Moonee Valley Racecourse Traffic Study
Technical Review

November 2011

This report is a technical review of the Development Master Plan for Moonee Valley Racecourse and has been undertaken by CPG Australia on behalf of the City of Moonee Valley.

Figure 1 - Development Master Plan Development Traffic Distribution

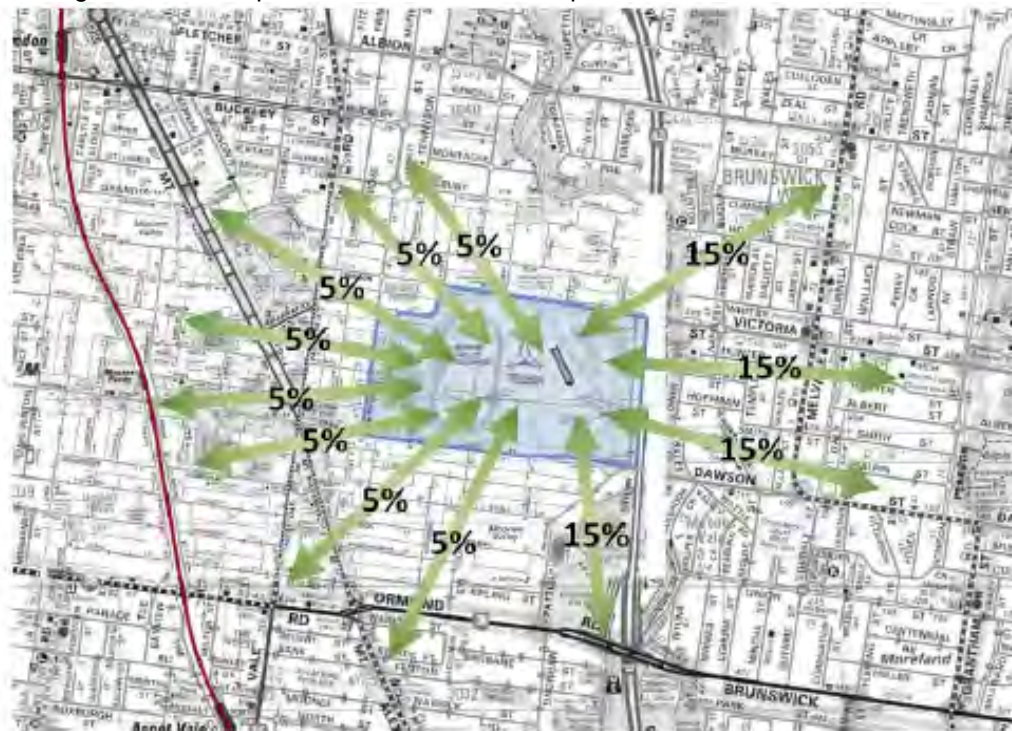
The traffic distribution used in the Development Master Plan, shown in Figure 1 and is discussed in the section above, is simplistic with no justification offered for the proportions used.

The traffic distribution presented in the Development Master Plan is relatively uniform (15% each to the North East, East, South East, South, West and North West and 10% to the South West) and does not appear to account for the different travel patterns for arriving and departing traffic.

Following these findings, traffic distribution assumptions in the micro-simulation are recommended to be adjusted.

Figure 2 - VITM Development Traffic Distribution for the AM Peak Arrivals (blue) and Departures (pink)

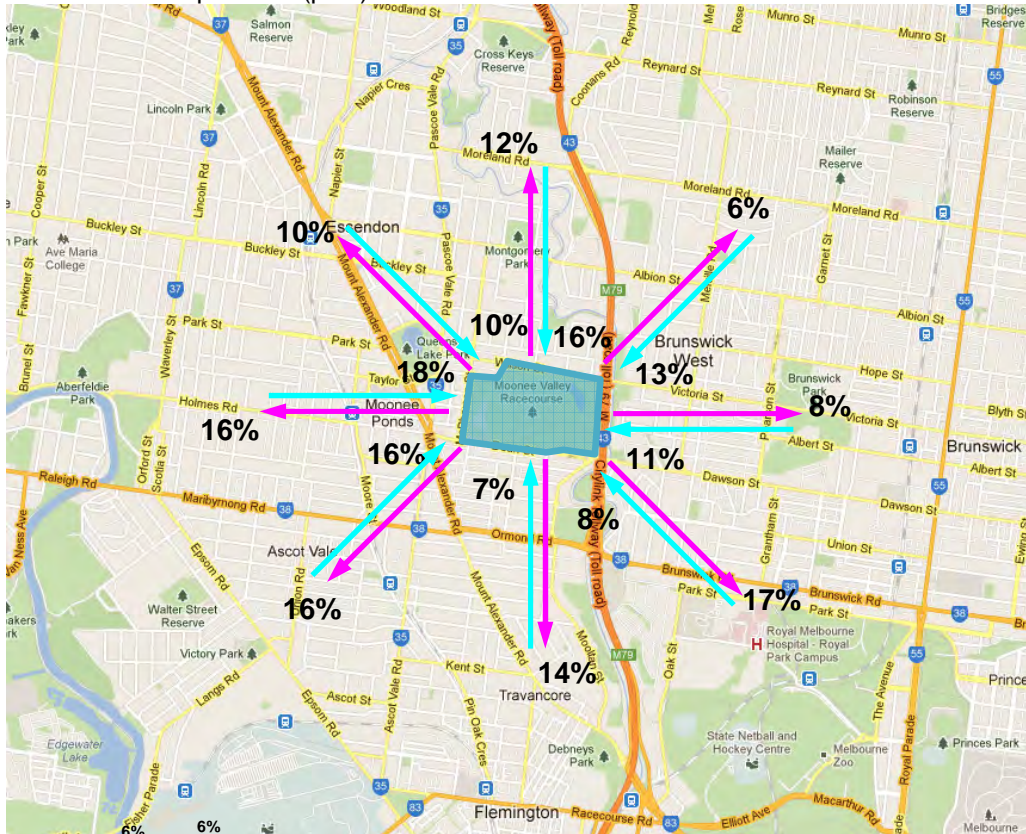
Figure 2 shows that the traffic distribution predicted by VITM is NOT uniform in all directions and rather has distinctive patterns.

Outbound flows are directed mainly towards the South and West (65% of all trips), with fewer trips to the North and North-West, and fewer still to the East and North East. This is consistent with the location of major employment sites in Melbourne.

Inbound flows show an inverse pattern, which is also justified as the trips appear to originate in primarily residential areas. It should be noted that, although there are large residential areas to the South and Southeast, these are further away from the study site than those of the North and West.

Figure 5 - VITIM Development Traffic Distribution AM Peak Departures

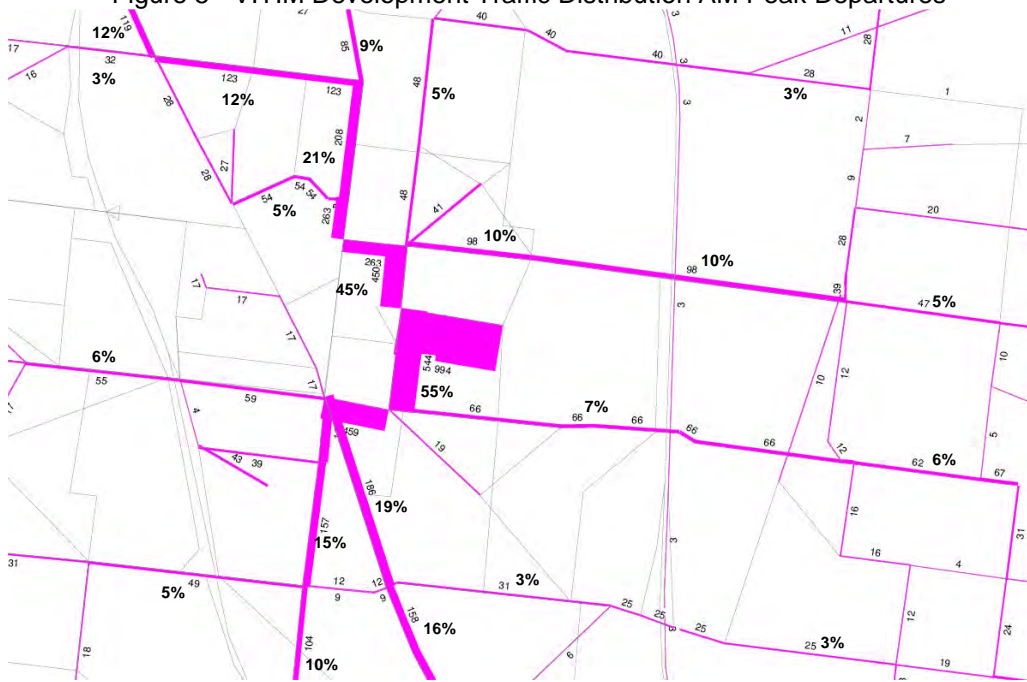
Indeed, the VITM model is reviewed in more detail it indicates that the distribution of development traffic on the local road network can be very complex due to the available routes. The distribution of the racecourse development traffic from the VITM model is shown in Figures 3, 4 and 5 for the AM peak. This level of detail cannot be derived from the analysis undertaken in the Development Master Plan.

7.2.7 Develop Initial Assignment Parameters

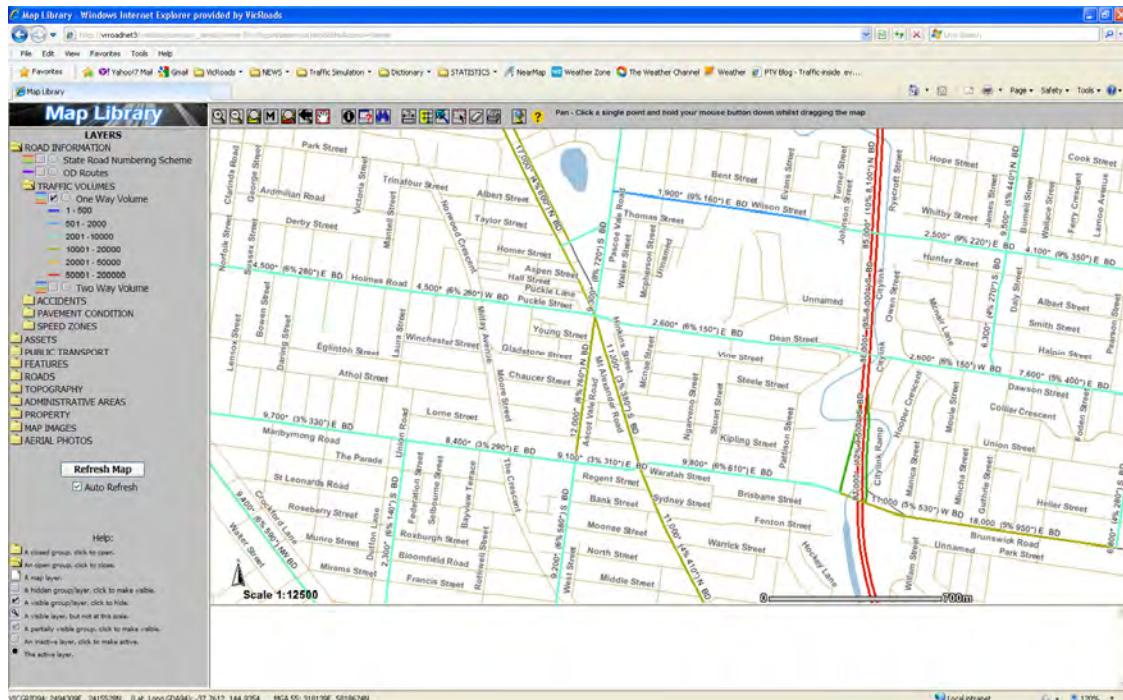
It is also necessary to check the consistency of input traffic volume data in the model.
